HUNTS POINT INTERSTATE ACCESS IMPROVEMENT PROJECT – CONTRACT 3

PIN X731.65, Contract D900055

Request for Proposals

Addendum #2

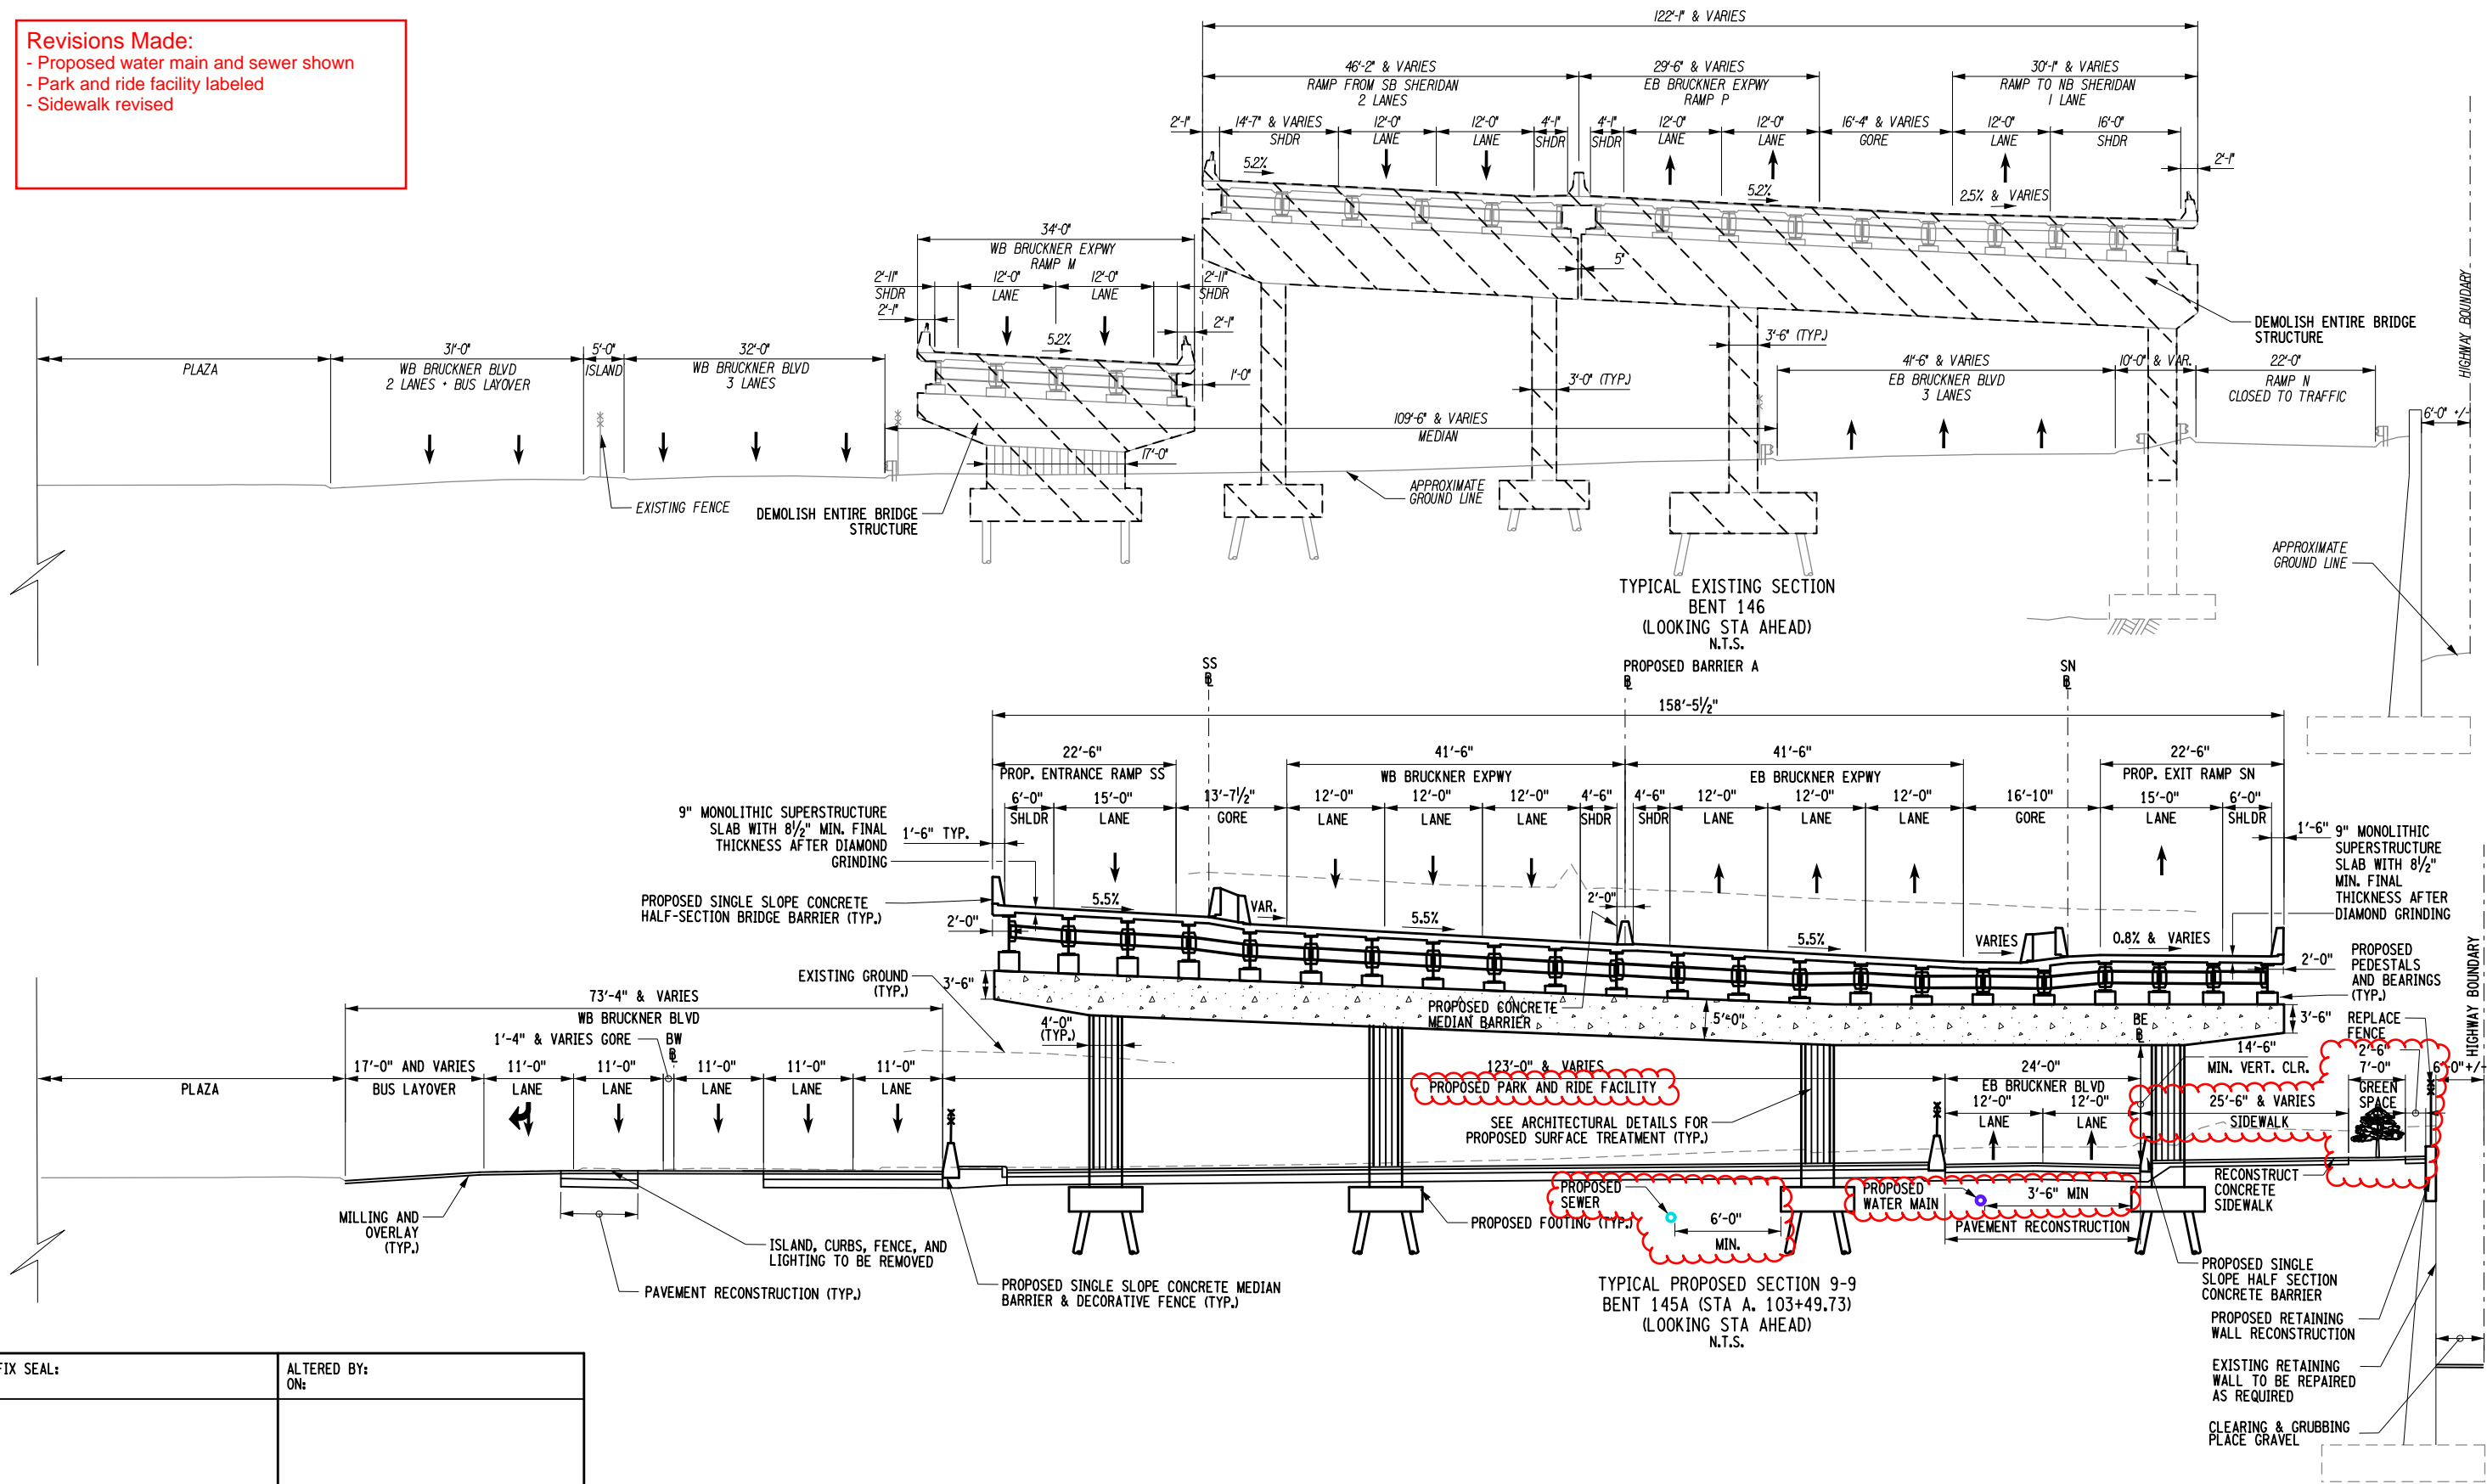
- Revisions Made:
- Proposed water main and sewer shown
 - Park and ride facility labeled
 - Sidewalk revised

PIN X731.65	BRIDGES	CULVERTS	ALL DIMENSIONS IN FT UNLESS OTHERWISE NOTED	CONTRACT NUMBER D900055
			INDICATIVE PLANS TYPICAL SECTION 13-13	DRAWING NO. TYP-13 SHEET NO.

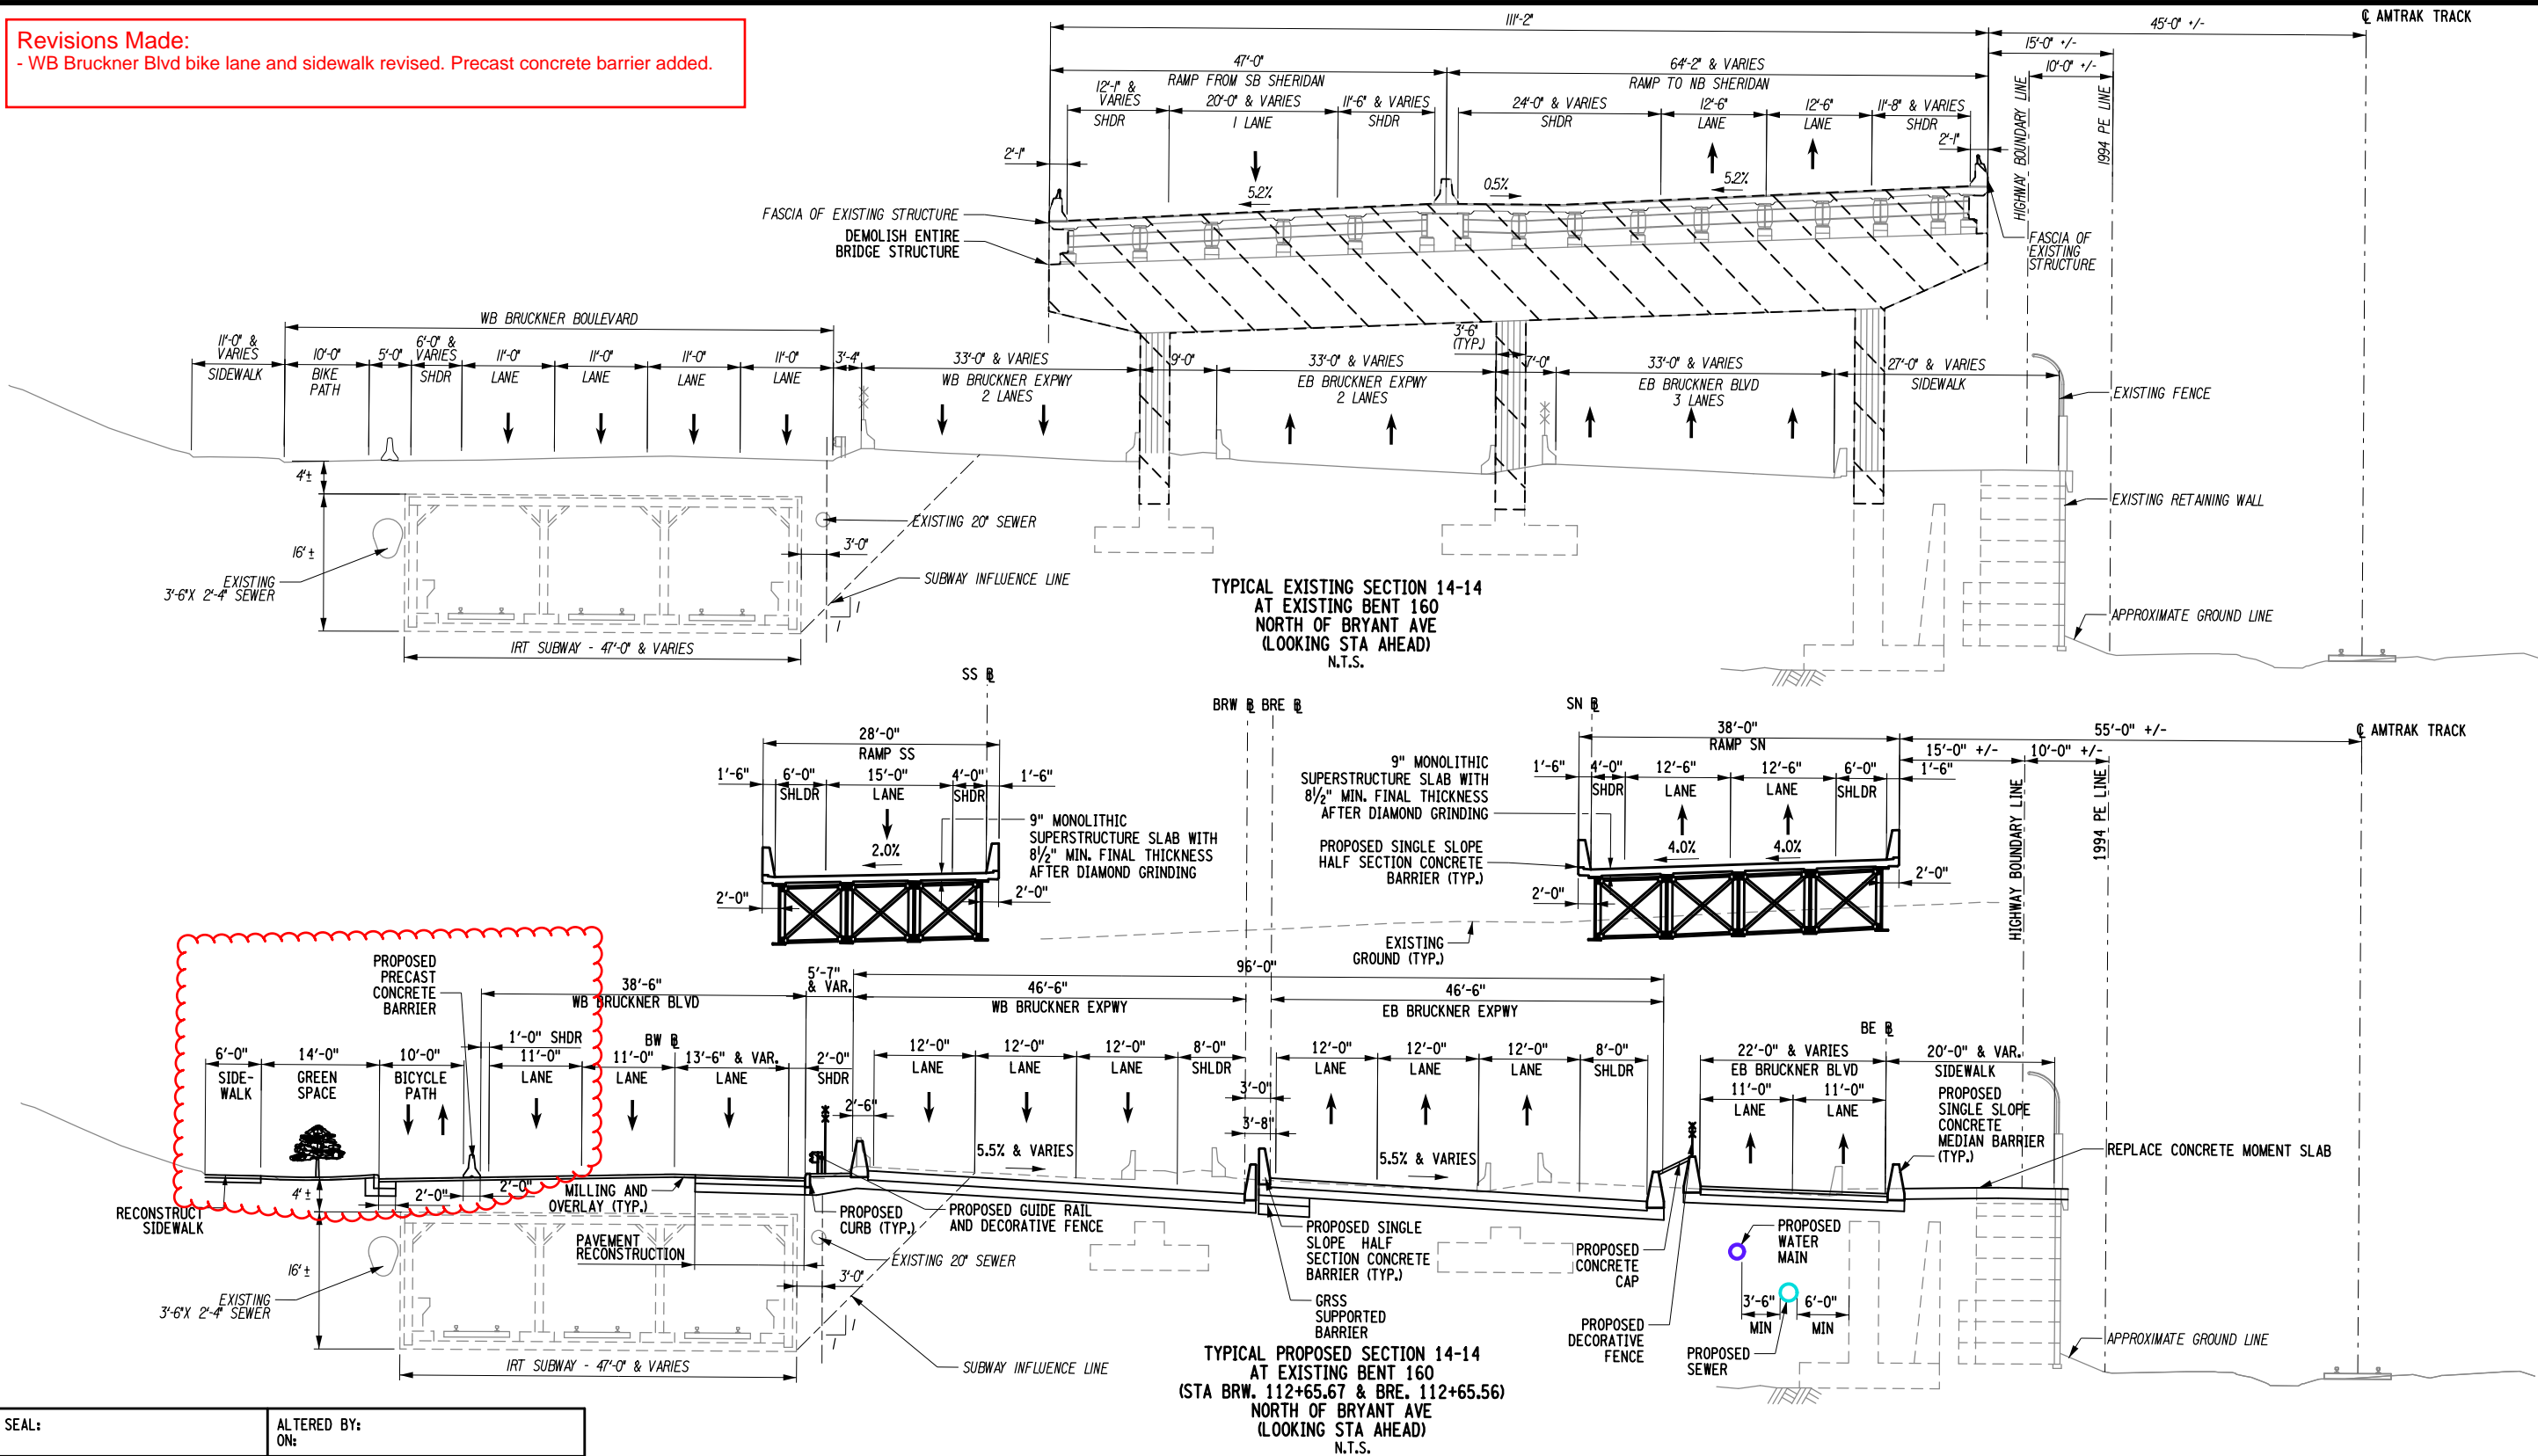
Revisions Made:
- WB Bruckner Blvd bike lane and sidewalk revised. Precast concrete barrier added.

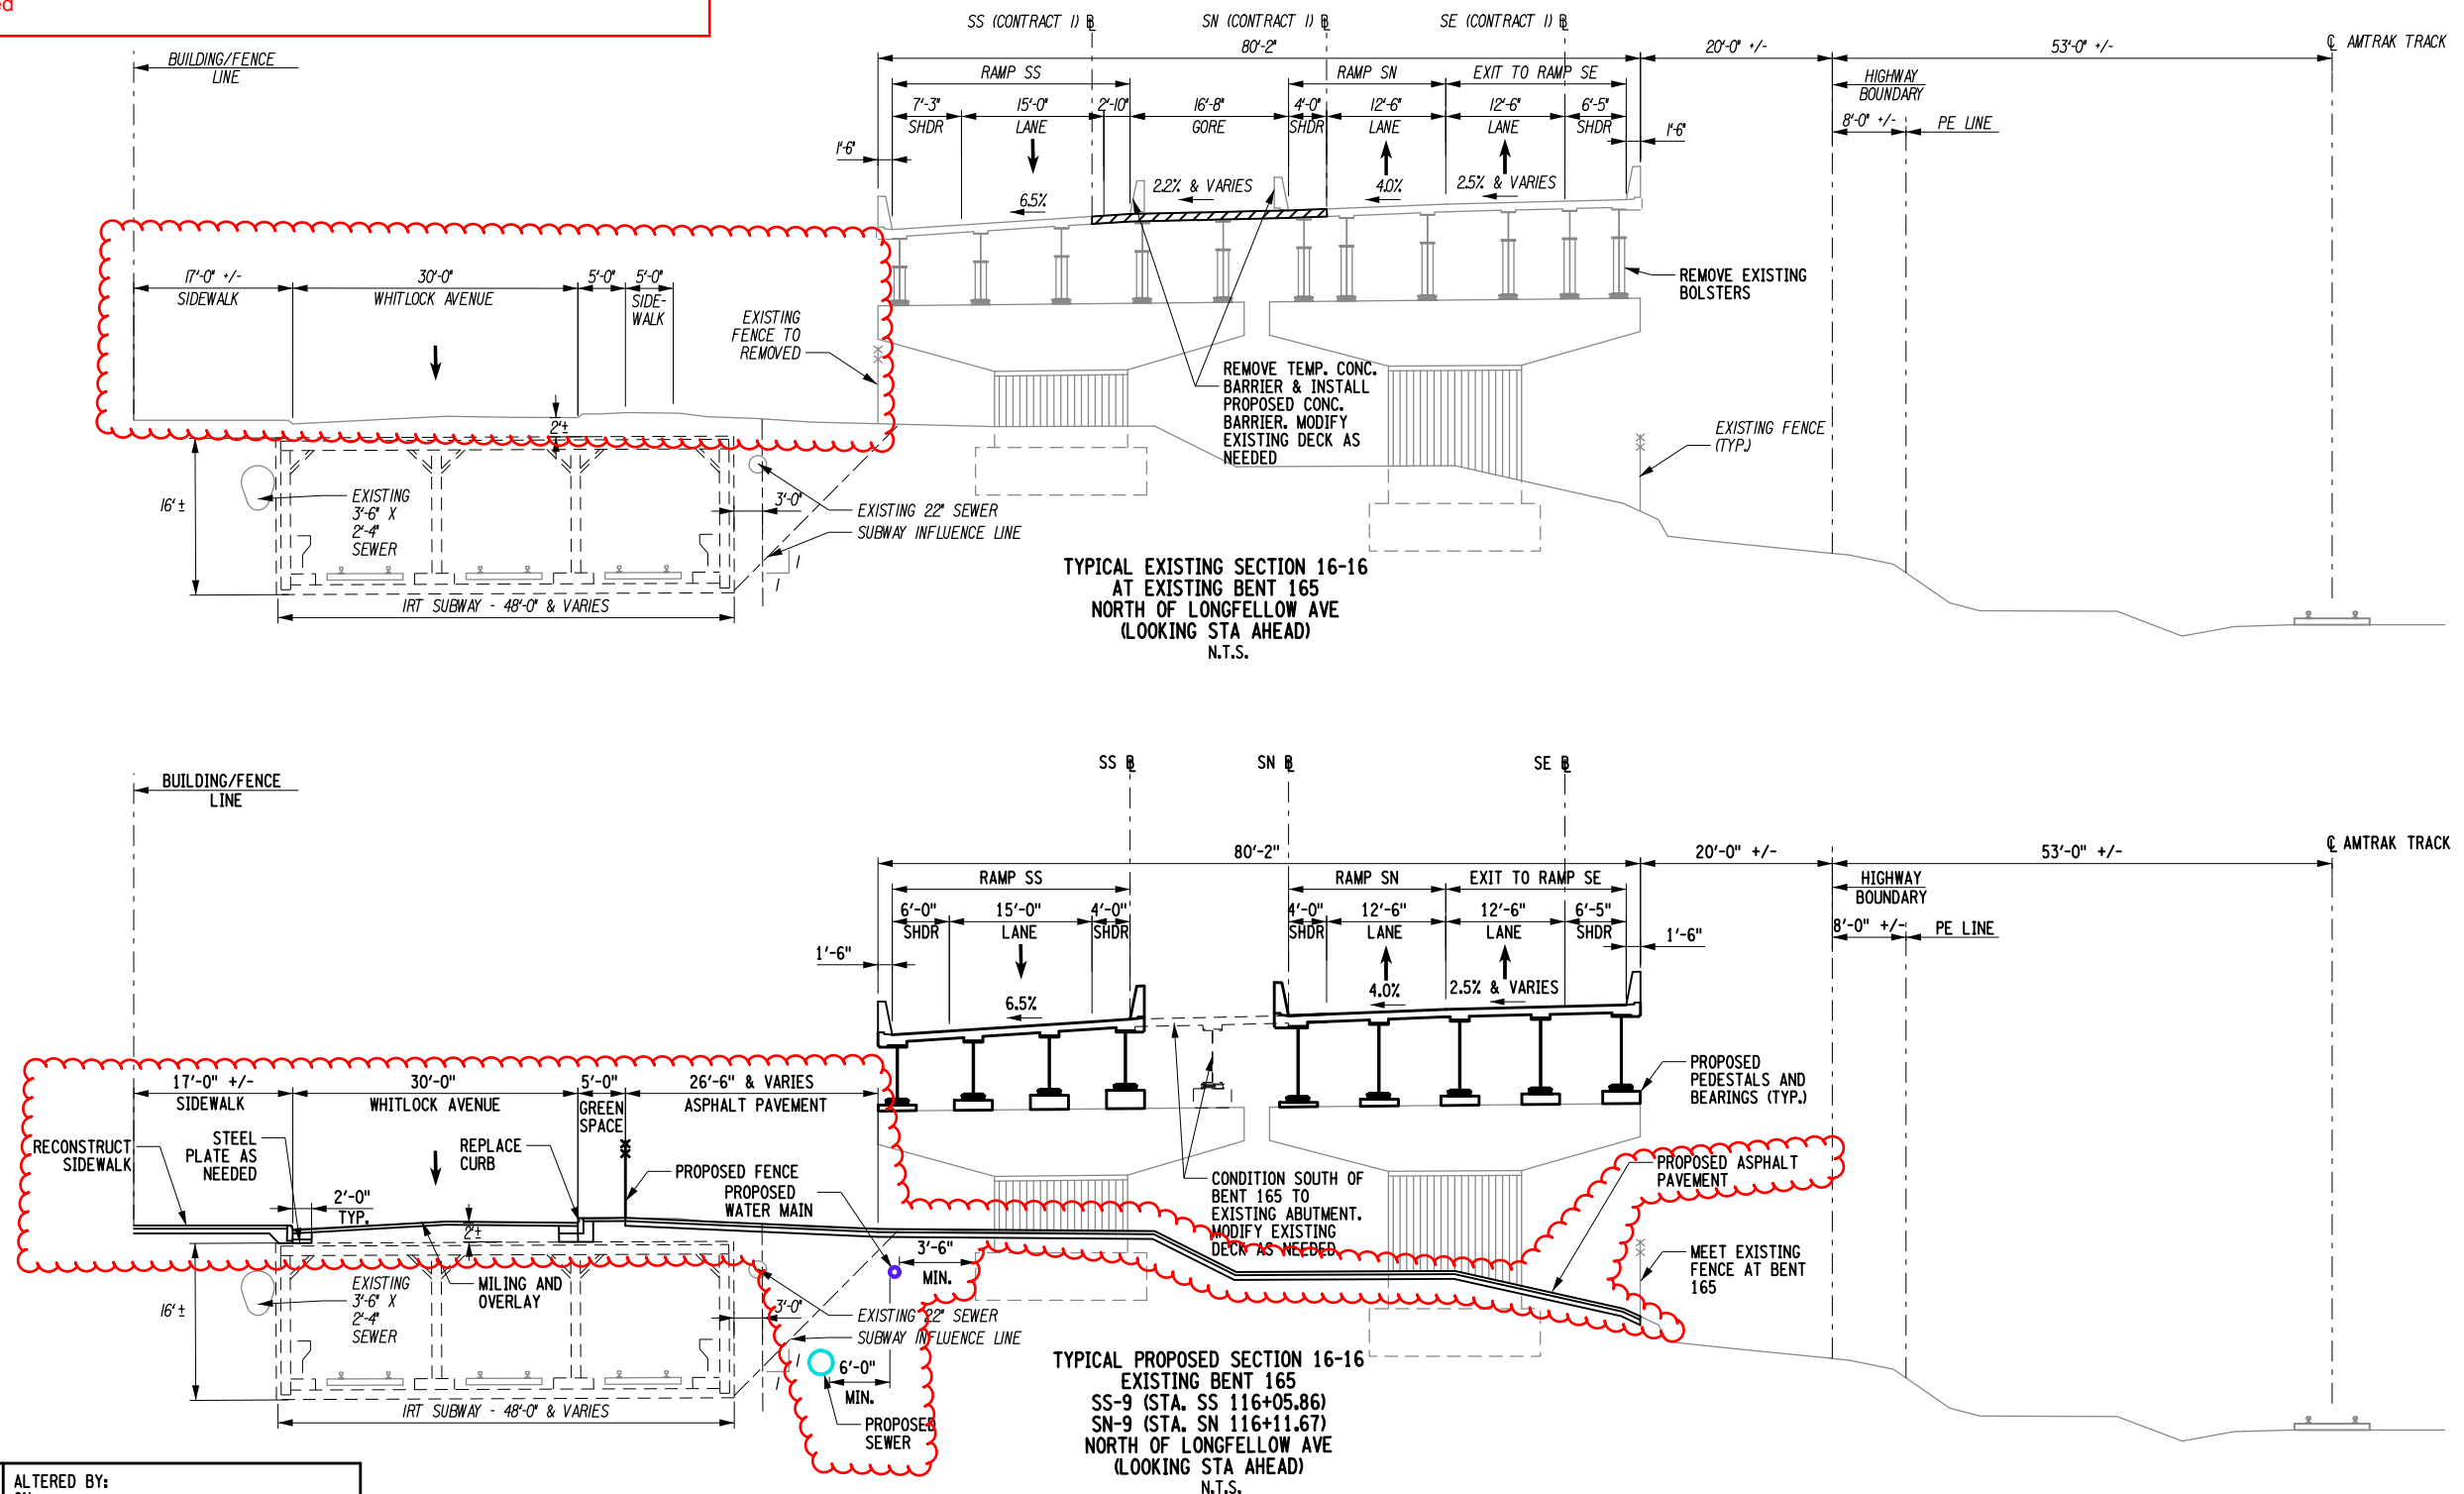
- Existing dimensions labeled
- Proposed water main and sewer shown
- Proposed At-grade work added
